**RE: RESPONSE TO ISSUES, PROPOSED BELOW WATER EXPANSION, MCKINNON PIT
TOWNSHIP OF LANARK HIGHLANDS, LANARK COUNTY**

We have reviewed the comments that apply to the geological and hydrogeological study from Ministry of Natural Resources and Forestry (MNRF), Ministry of Northern Development and Mines (MNDM) and Mississippi Valley Conservation Authority (MVCA) and prepared a response.

Figure 1: Analysis of Radiation, Radiation, Sieverts per year (Sv/yr)

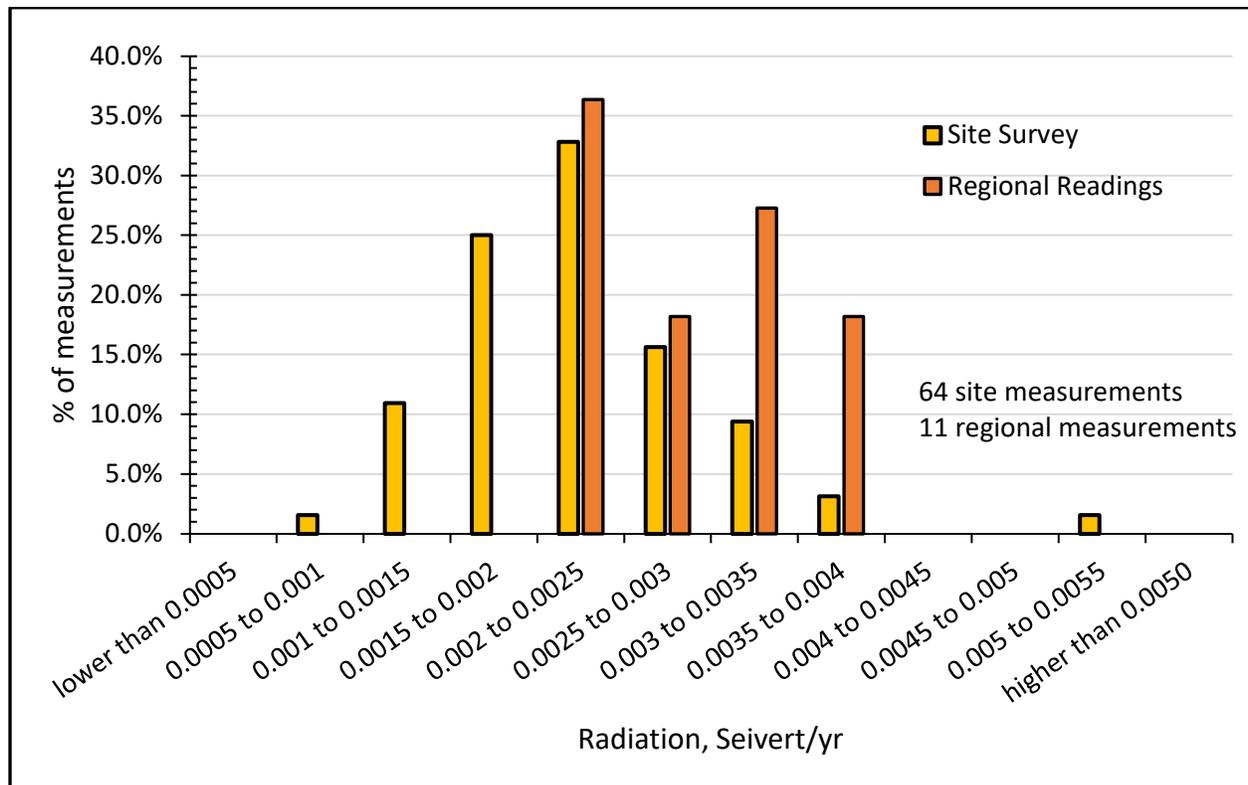
Topic, Comment	Agency	Location of Response, Summary
Radioactivity/ Health and Safety		
Barbers Lake Granite contains uranium and thorium, and the proponent should determine the risk of excavating the material will have on Arnott staff.	MNDM	See Section 2 The gamma-ray spectrometric survey did not find radioactive concentrations on or near the site that were anomalous or above what would be considered normal natural concentration at an inert location. Comparable concentrations were measured at other locations in Lanark and at locations in Ottawa.
Water Balance/ Water Budget		
A monthly, annual and long-term water budget and hydrologic analysis is recommended.	MVCA	See Section 3 Additional details on annual, monthly and future water budgets are provided.
Groundwater		
Identify and show that there are indeed two aquifers on the site that have a 5+ m difference in heads.	MNRF (AUG 22/23)	See Section 4 This section provides additional field details to differentiate the two aquifers

To address the comments about the presence and safety of radioactivity at the site, a gamma-ray spectrometric survey was completed. The results showed that uranium concentrations were nominal, present throughout the pit and around the site in levels that are background and are comparable to or less than concentrations measured at other locations in the region.

The most sensitive Ludlum scale factor of 0.1 was used and the counts that were measured barely registered at any point on the site. The results shown in Table 1 and shown in OS Figure 1.

The readings are within the concentration that would be considered background. They are similar to the measurements taken at other locations in Lanark and within the City of Ottawa (Table 2, and inset OS Figure 1). The survey shows the aggregate resource on the site does not contain anomalous concentrations of radioactive material. The site is a pit, which will extract granular material. The application will not excavate or process bedrock and will therefore, the operation will not disturb the current bedrock.

The results of the survey confirm that the aggregate is safe, and there are no concerns of uranium exposure to those attending or working at the site.

Figure 7: Schematic Cross-Section, Present Setting Aquifer Interaction

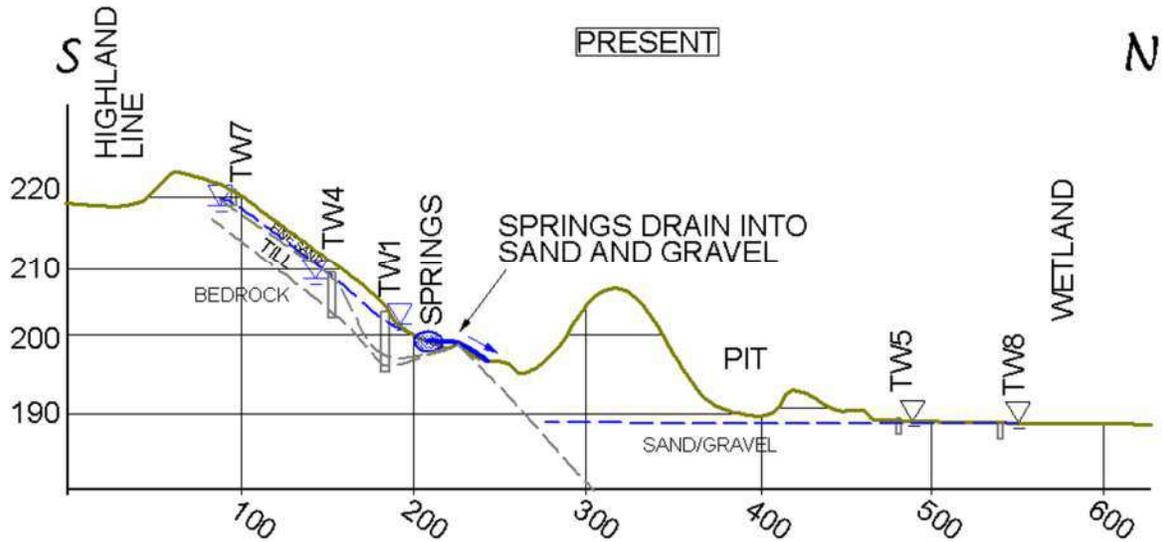
20. Given the above comments 16 to 19, please update the monitoring program, triggers, and mitigation measures to account for the presented data, any new findings, and the functions of the natural heritage features.	MNRF (OCT 28/24)	The addendum recommendations have been added to the site plan. Landowner permission is required to access recommended surface water monitoring stations SW1, SW2 and SW3.
The area is designated by the County of Lanark as significant groundwater. This needs to be addressed further in the report	MVCA	Section 6 provides further discussion about the significant groundwater recharge area.
More data on the perched aquifer is required.	MVCA	Section 4.2 Additional data on the perched upland aquifer and the relationship to the primary granular aquifer is provided.
Additional details on the perched unconfined, unconfined and confined aquifers such as locations, elevations, interactions and	MVCA	Section 4 Additional data on the perched upland aquifer and the relationship to the primary granular aquifer is provided.

The flow was evaluated from TW1, TW4 and TW7 and the springs zone. The aquifer intersects the ground surface on the north-facing slope along the south-west part of the site. The perched water table emerges as springs in a zone that was documented to be between approximately 195.6 to 197.6 mASL. The discharge from the springs infiltrates into the glaciofluvial deposit within approximately 70 m.

Groundwater flow in the upland perched aquifer is northward from the topographic high along Highland Line Road to the pit. The area where the springs were mapped is shown on OS Figure 2. As shown on the schematic profile in Figure 7, the water from this system exits along the bedrock/till interface at the base of the hill. Water from these springs flows overland for less than 70 m along the bedrock surface before infiltrating into the glaciofluvial system.

Figure 10: Groundwater Temperature, Granular Aquifer

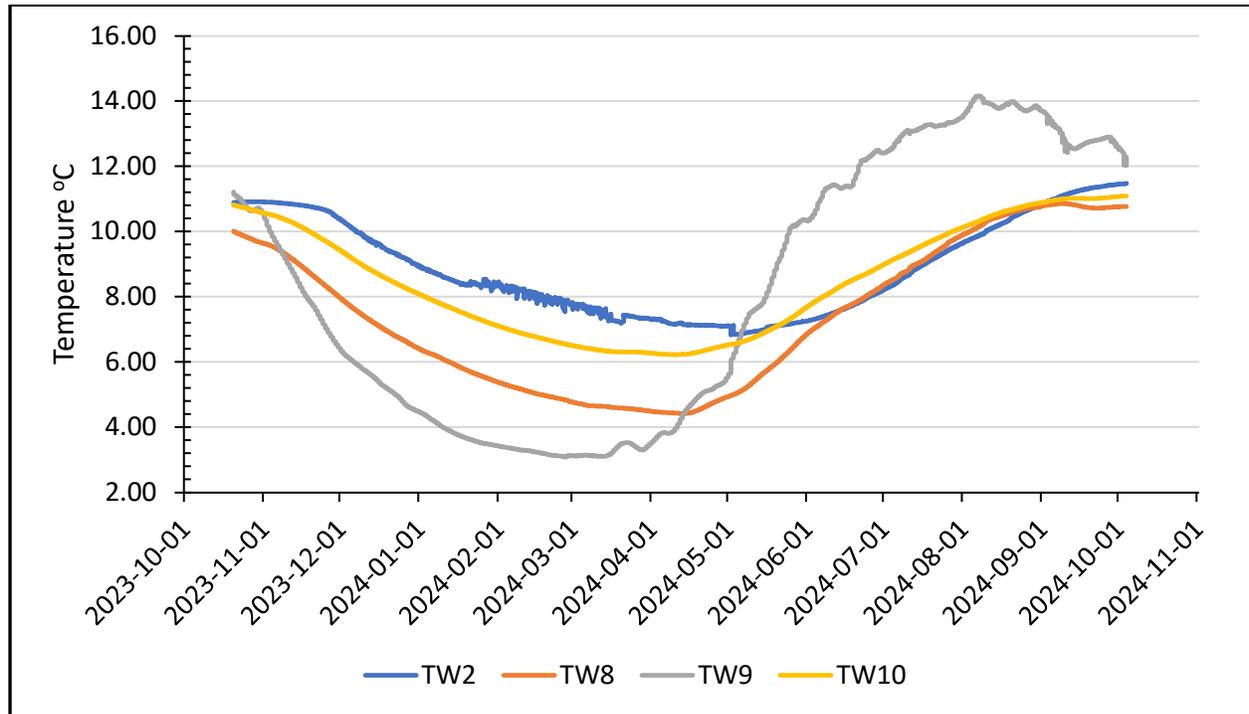
19. Please provide evaluation of the potential thermal impacts on the cold streams using site-specific data.	MNRF (OCT 28/24)	
Update the monitoring program with any wells and other monitoring points completed to address the points above.	MNRF (AUG 22/23)	Section 4.3 Additional groundwater monitoring data is provided.

Figure 10 shows the temperature measured for the four stations over the period from October 2023 through July 2024. TW2 is in the pit floor along the northern periphery of the extraction limit. TW8 and TW10 are shaded by a tree canopy and are in the wetland on the McKinnon property boundary. TW9 is in the open within a depression adjacent to the snow mobile trail that crosses the wetland.

At TW8 the water temperature decreased from approximately 10 °C in October to a minimum of 4.29 °C in April before increasing to 8.83 °C in late July. The temperature in July at TW8 was slightly higher than the temperature of the groundwater in TW2 (8.41 °C).

At TW9, which is in the open area showed the greatest range in temperature, from a maximum of 14.10 °C in August (2024), to a minimum 3.08 °C in March (2023). The rate of temperature increase and decrease was the steepest of the four monitored wells, and was about twice the rate as TW8 and TW10 and had the highest temperature of any in August at 14.10 °C.

At TW10, the temperature trend was similar to TW8, although the absolute temperature was on average 2 degrees higher. The temperature decreased from 10.78 °C in October to 6.25 °C in April then increased to 9.53 °C in July. The temperature was higher than in the pit at TW2 from late May through the summer.

The temperature in the pit, at TW2 decreased from 10.78 °C comparable to in TW10, to a minimum of 6.83 °C in April. The rate of decrease in temperature over the winter was comparable to TW8 and TW10, but the increase in temperature in the spring was slower than at the wells in the wetland.

OS FIGURE 4

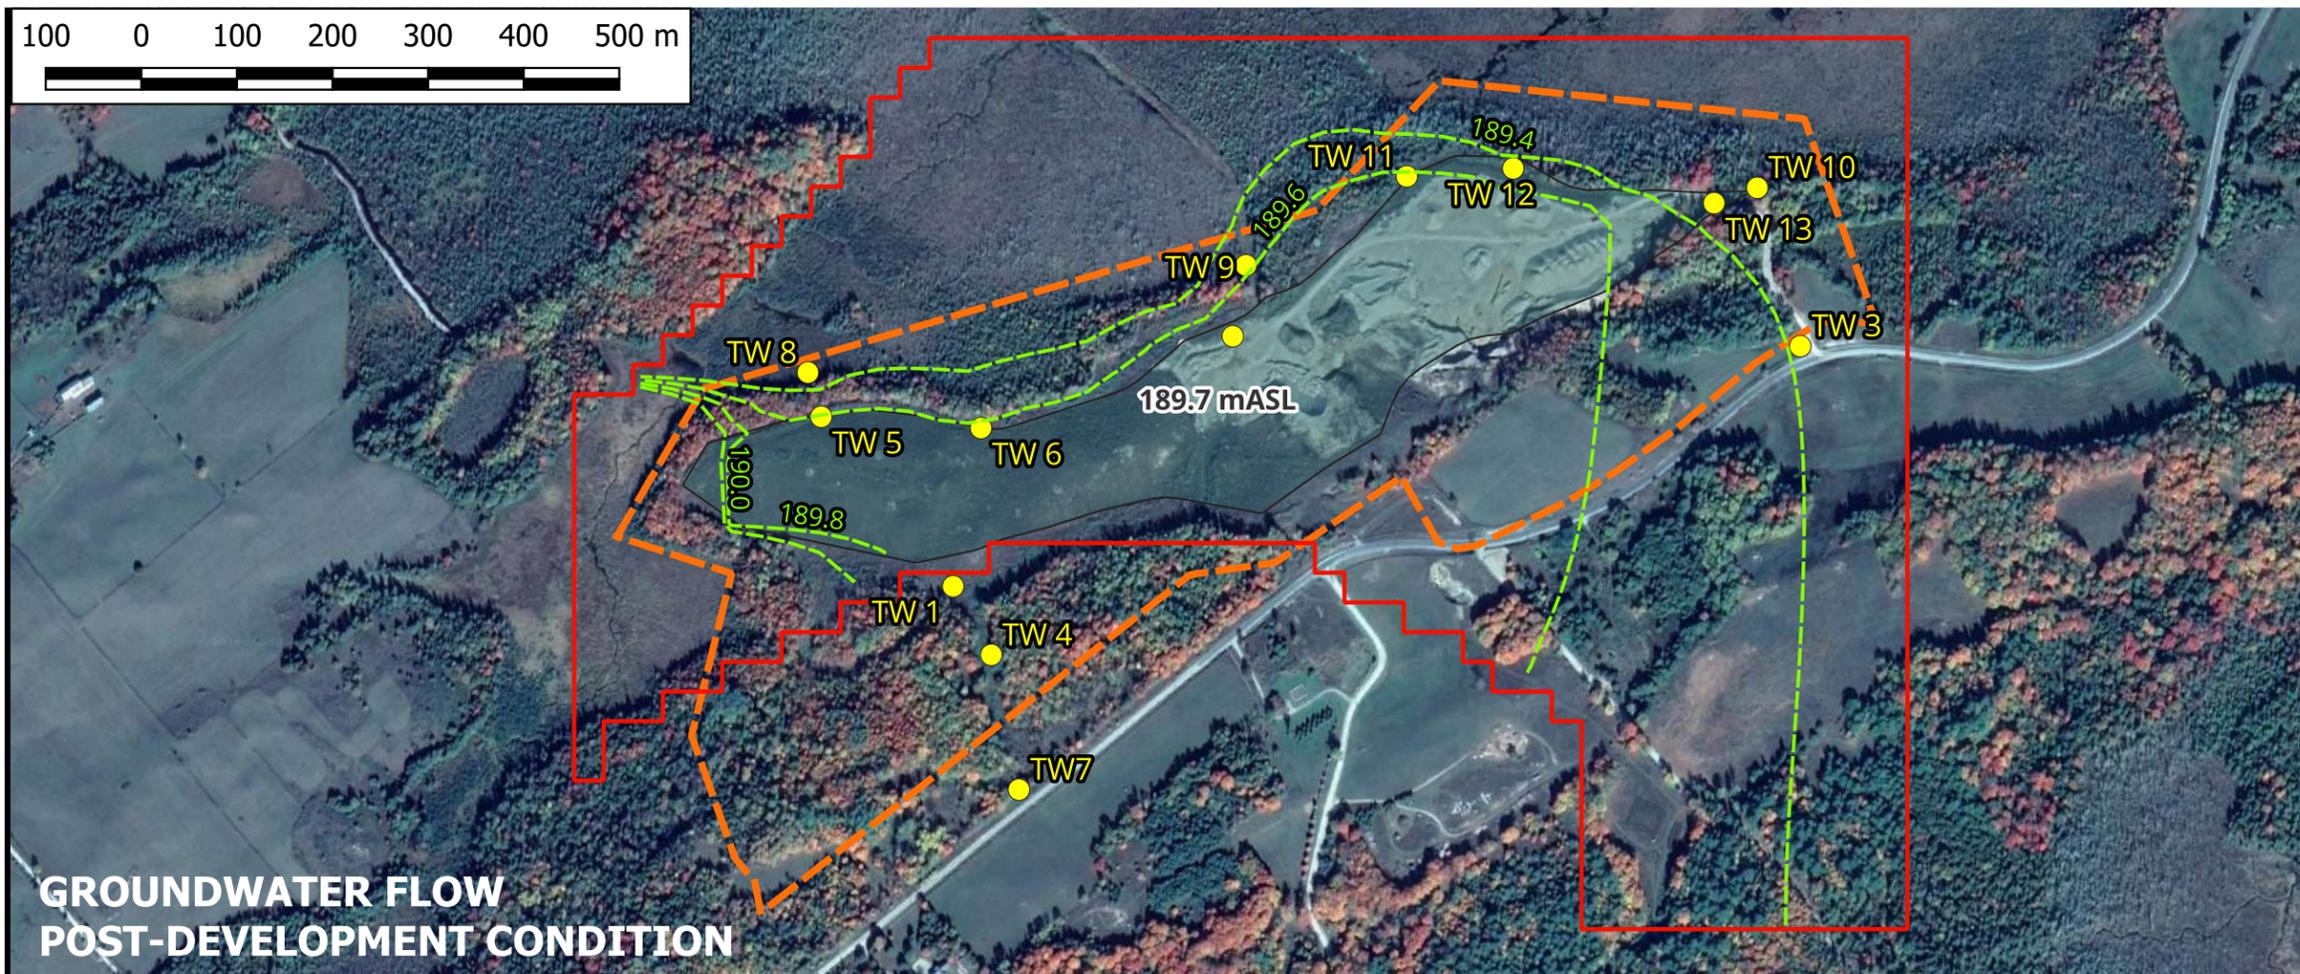
Topic, Comment	Agency	Location of Response, Summary
will influence the adjacent wetlands and streams. Data from additional monitoring wells might provide a more comprehensive understanding of the final elevation of the rehabilitated pond level across the site, aiding in the assessment of possible impacts.		
Show seasonal variation in water levels in pit and adjacent wetlands and cold streams	MNRF (AUG 22/23)	Section 4.3 Contains additional seasonal monitoring data, with additional monitoring points in the wetland adjacent to the pit. Field measurements taken from the closest watercourse with locations chosen in consultation with Ecological Services.

The resultant groundwater surface was estimated using MODFLOW6. A 2-dimensional model was created but the use of the numerical model permitted a more complex geology of the site to be considered. The model examined the granular deposit and considered recharge and the wetland. The

groundwater flow was first calibrated to the average water levels collected over the study, and subsequently the final lake was added. The results are shown on OS Figure 4. The results show that the effect of the lake decreases quickly with distance, as would be expected. Within about 30 m from the lake edge, the post-development water level would be restored from the initial 0.28 m to about 0.10 m.
